# FIVE ESTUARIES OFFSHORE WIND FARM

## 10.20.1 TECHNICAL NOTE: METHODOLOGY FOR DETERMINING MDS (OFFSHORE) – REVISION C (TRACKED)

Application Reference:	EN010115
Application Document Number:	10.20.1
Revision:	C
Pursuant to:	Deadline 6
EcoDoc Number:	005395492-04
Date:	February 2025

Figure 1 Offshore cable crossings

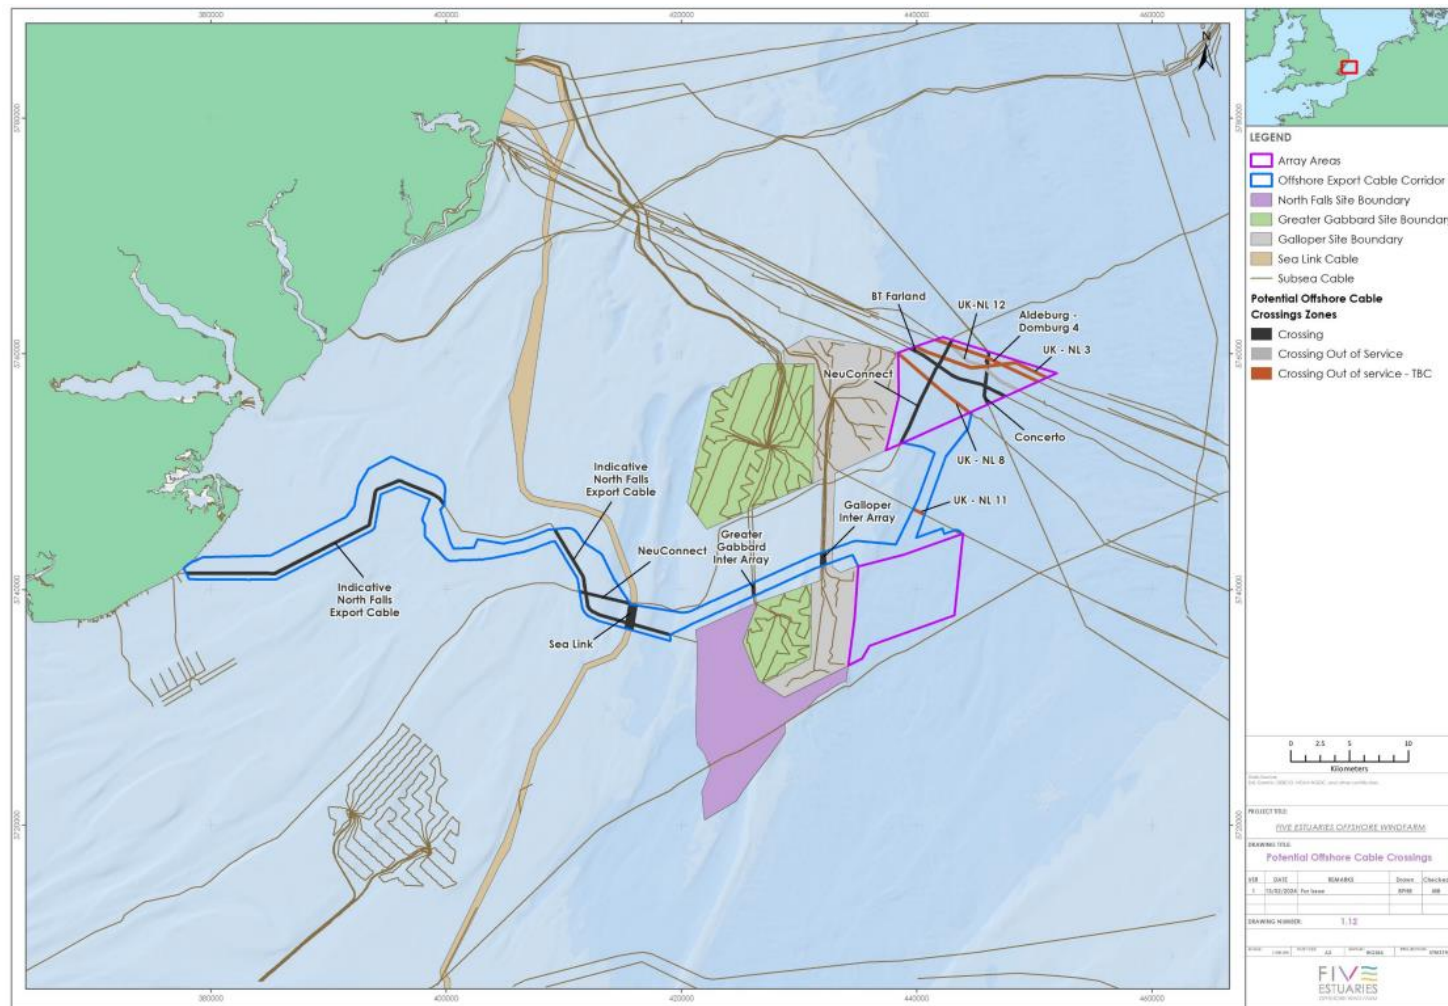
b) Paragraph 2.1.3 restates that the maximum number of cable crossings has been set at 56. The Applicant must present a detailed explanation of how this parameter has been established, including any assumptions made.	Further details are provided in Section 2.1.

2.1.4 Figure 1 has been extracted from the Offshore Project Description [APP-069](#). It can be seen that there are a number of planned, active, inactive / out of service cables in the Export and Array area. This has been further summarized in Table 2.

- 2.1.5 The project has allowance for 56 cable crossings. At least 14 of these are anticipated to be for the export cables in the Export Cable Corridor (ECC). This leaves 42 for the array areas. It is not possible to identify the number of crossings in the array area until the final layout and array routing has occurred, and this will not be done until after DCO award. Similarly there are a number of OoS cables where though it is assumed the preference is to but remove these, however this is not confirmed yet. This is why the project cannot confirm the total number of crossings and instead has to make an allowance based on a range of possible scenarios.

**Figure 7 Transect at exaggerated 1:50 Vertical:Horizontal scale with rock berm circled (please see Annex A).**

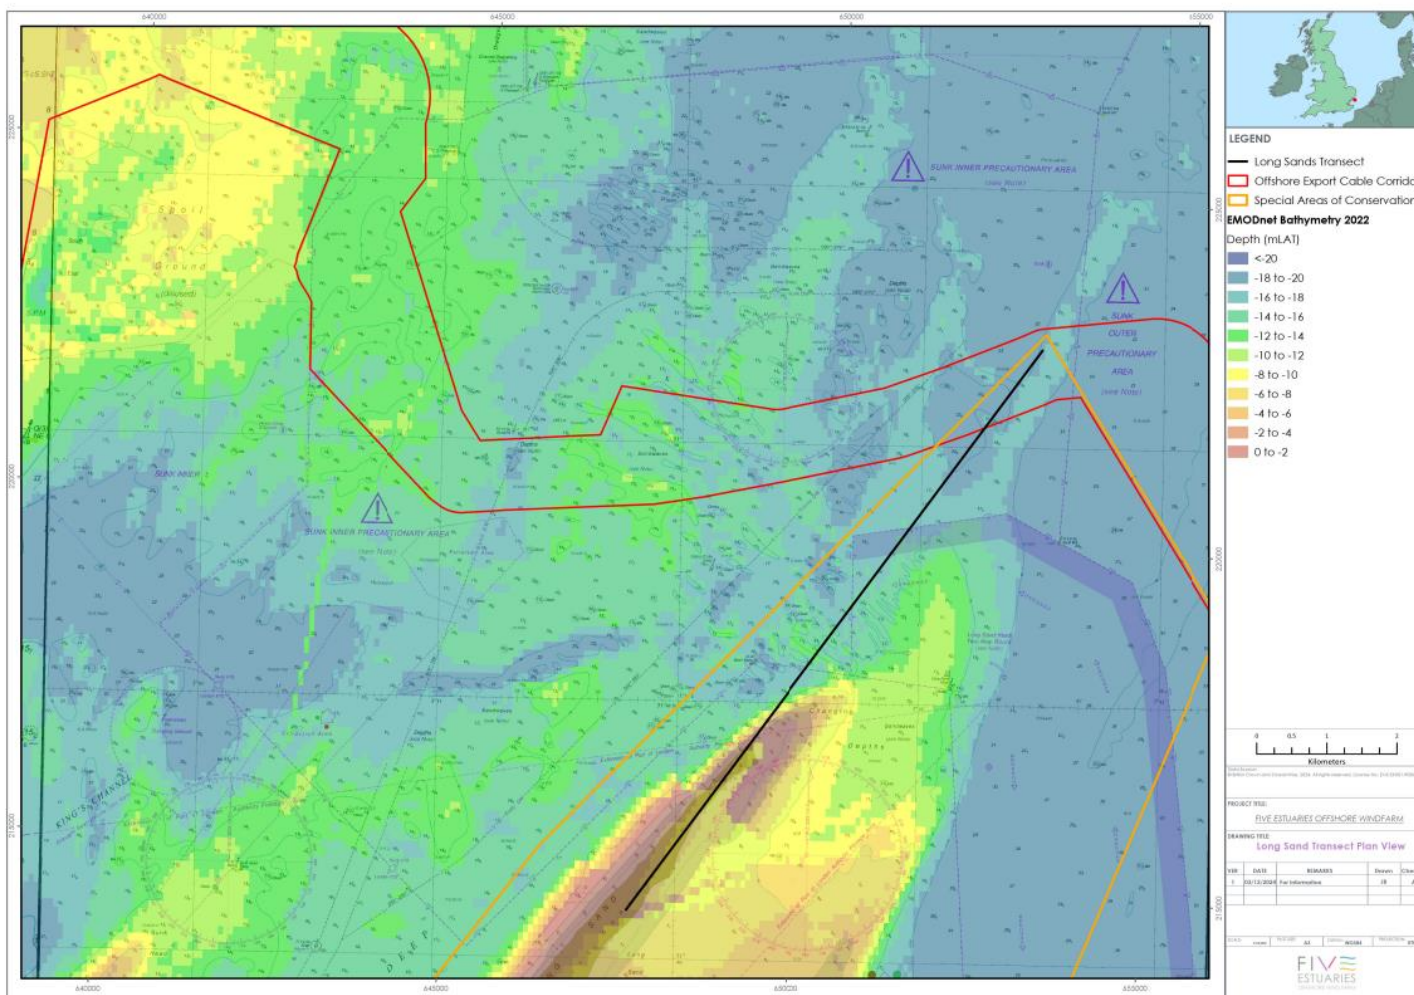
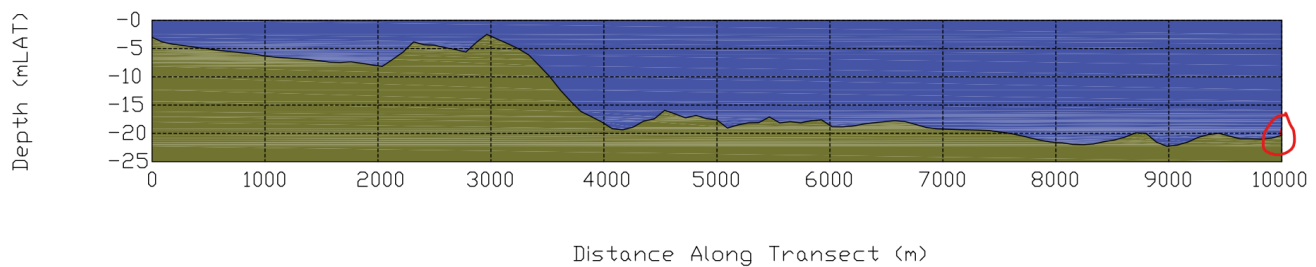
c) Paragraph 2.2.2 refers to the potential for a very small volume of sediment being trapped within rock voids and/or accumulating on the updrift side of berms of the cable protection, if required. The Applicant is requested to quantify the volume or provide an estimate of the maximum expected volume of such sediment.	An estimate of the volume of trapped sediment has been provided in Section 2.2. Context for this volume is provided in relation to the tip of the Margate and Long Sands (MLS SAC) sand bank which intersects the Export Cable Corridor (ECC). The relative volumes of potential trapped sediment and the tiny proportion of the nearby sandbank demonstrate that the potential effect of the project is not material.

- 2.2.7 To put this in context of the size and proximity to the Margate and Long Sands sand bank a transect is shown below in Figure 6 and Figure 7. Transects at 1:20 and 1:50 scale are provided in Annex A: Transects at 1:20 and 1:50 V:H scale (printed at A3)

2.2.8 The Applicant cannot find a reported value for the volume of material in the Margate and Long Sands Sand bank, hence a conservative estimate is made below:

For the 4000m shown in the figure **which is circa 10% of the total length** from the northern tip to the southern this equates to 24 million  $m^3$  of sand.

Figure 8 Historic bathymetry of the M&LS shown on marine charts

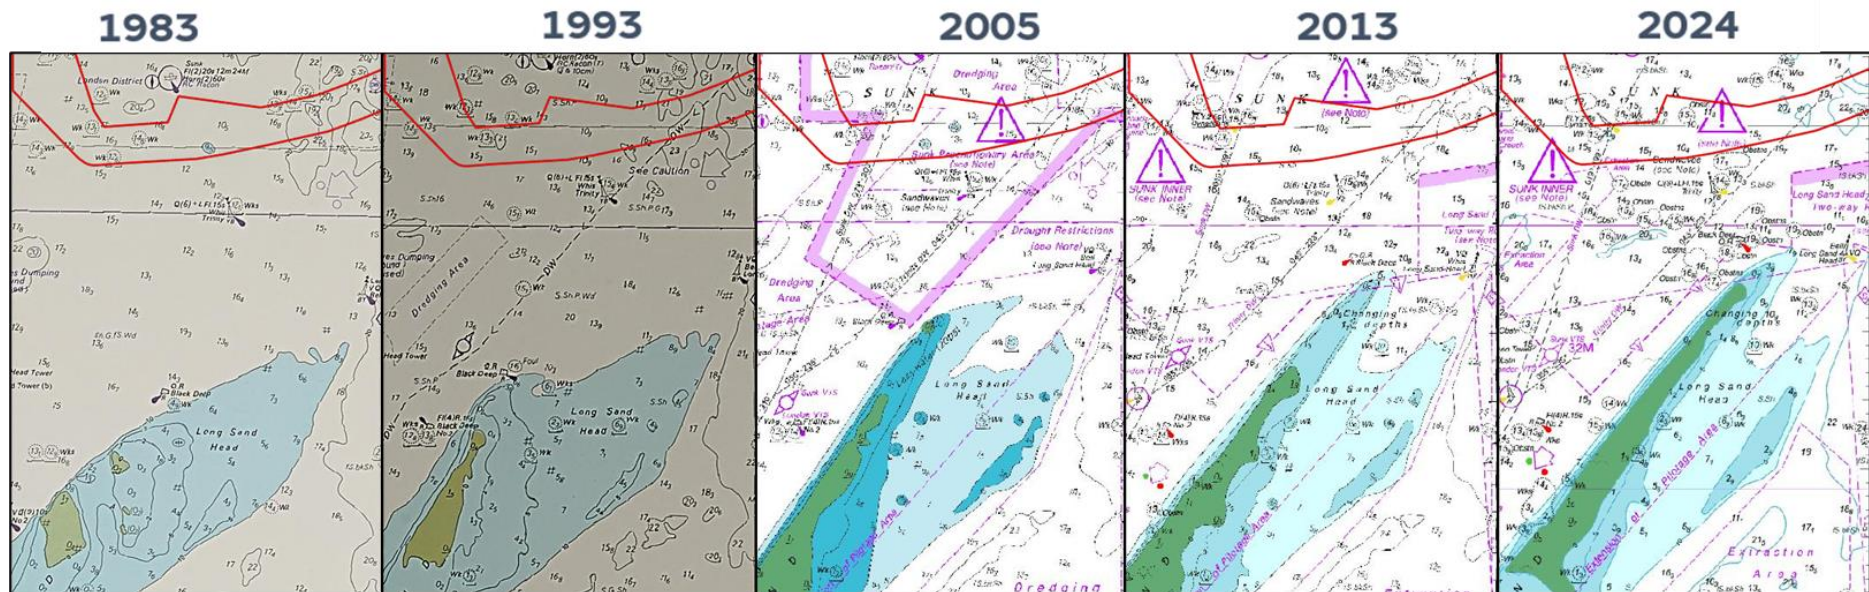
d) Paragraph 2.2.4 states that monitoring and observation of operational offshore wind farms shows that large scale morphological features are not affected by the presence of assets (cable protection) and that scour impacts would be very small. The Applicant is requested to ExQ2	Covered in section 2.2.9 and 2.2.12.

2.2.10 To support the assertion that the sand bank is controlled by processes that are orders of magnitude larger than the maximum impact of the project, the Applicant refers to the historic movement of the sand bank shown in Figure 8 below.

2.2.11 The volume involved in this movement are in the order of magnitude of hundreds of millions of  $m^3$  of sand each decade.

2.2.12 The Applicant maintains the worst case installation of cable protection in the ECC and array areas combined are many orders of magnitude too small to impact either the M&LS sand bank or the wider sediment transport processes in the area.

**Figure 9 Sediment dispersal during jetting (IMCA Code of Practice for Offshore Cable Laying in the Renewable Energy Industry M264 Rev. 0.1 – November 2023)**

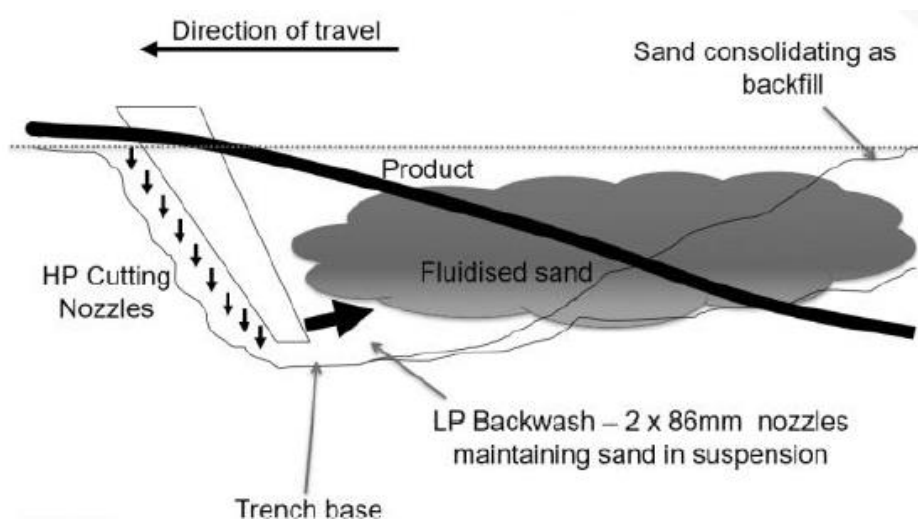
Responses by Deadline 4 (3 December 2024) Page 13 of 29 Question to: Question submit evidence in support of this	
e) Paragraph 2.4.2 states that a 50% assumption has been applied to sediment disturbed from fluidised material dispersed during cable trenching. This information seems to contradict the Applicant's response at Deadline 1 [REP1-051] that an assumption of 100% of material is fluidised and displaced. The Applicant is requested to clarify what has been considered in the assessment. The ExA notes that Table 2.8 in [APP-071] states that a sensitivity check on 100% of material ejected in local areas was undertaken. The Applicant is requested to confirm where this is presented in the Application documentation.	Further explanation is provided in Section 2.5.

2.5.2 The total volume values in this table are estimated with a 50% assumption, regarding the amount of sediment disturbed. This value was used because in most cases during simultaneous cable lay and bury activities, the trenching not less than 100% of the material from within the trench profile is expected to be dispersed-ejected into the water column. An example of this for jetting is shown in the sketch in Figure 9. Whilst sSome of the sand-fluidised seabed sediment is fluidized-ejected into the water column and may disperse as a plume, however somea large proportion (maximised by design) is also deliberately retained within the trench to provide immediate backfills s over the cable.

2.6.22.5.4 -We note that tThe values in the table for the maximum total volume values in the table are the same if calculated from either using a typical average burial depth of 1.75 m and a 100% ejection assumption, or, tif using the maximum value burial depth of 3.5 m and a 50% ejection assumption. These values provide a realistic worst-case scenario for sediment disturbance associated with cable laying.is a maximum indicative value. The actual burial depth will be below the average, hence this value has been used to assess the impact of sediment dispersal on sensitive receptors in the marine environment.

**Figure 10 Maximum length of cable in SAC**

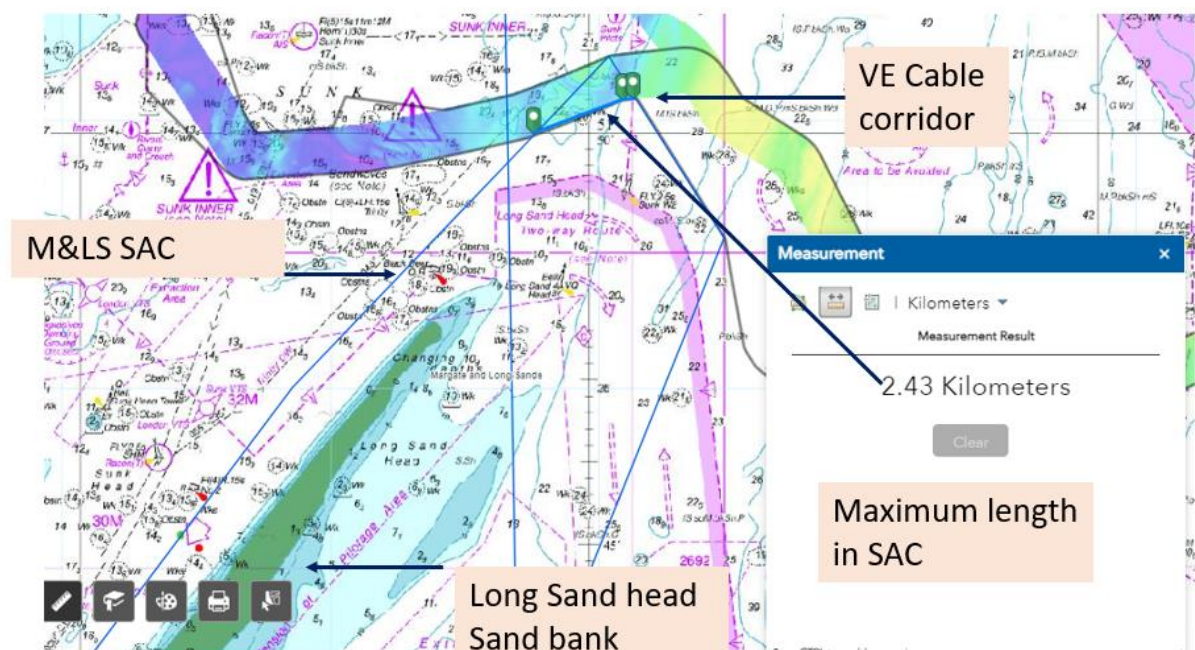
#### 3.1 HOW HAS MAXIMUM LENGTH OF CABLE PROTECTION REQUIRED WITHIN MARGATE AND LONG SANDS (MLS) SPECIAL AREA OF CONSERVATION (SAC) BEEN DETERMINED?

- 3.1.1 Theoretical max single cable length is estimated at circa 2.5 km as shown in Figure below. It can also be seen that the Long Sand Head sand bank feature is 4-5km from the cable corridor and separated by the Long Sand Head two way route (Shipping Lane) used by vessels transiting to the ports.

- 3.1.2 This would be hugging the southern corridor edge. The project cannot conduct the final routing until post DCO, however the Applicant has committed to the following *“Final cable routing will seek to take the shortest route through the M&LS SAC where possible”* (9.13 Margate and Long Sands SAC Benthic Mitigation Plan [APP-243 Table 9.1]).

3.1.5 Based on the ground conditions, and variations in potential final route lengths through the M&LS SAC, a total length of 900 m of cable protection (5,400 m<sup>2</sup> and 5,400 m<sup>3</sup>) in the SAC has been assumed as the realistic MDS. It could be a combination of lengths up to 900 m and the location of the cables could be anywhere within the offshore ECC corridor. A highly conservative assumption of 50% of the cable would require protection has then been applied to an assumed routing of 900 m per cable in the SAC. This has been combined with an assumed mattress width of 6 m to result in the 5,400 m<sup>2</sup>. Whilst this value is considered highly conservative by the Applicant and the most likely scenario is that no external cable protection will be used, the assessment has been based on 5,400 m<sup>2</sup> to allow for a degree of unforeseen ground conditions that may require a small amount of cable protection.
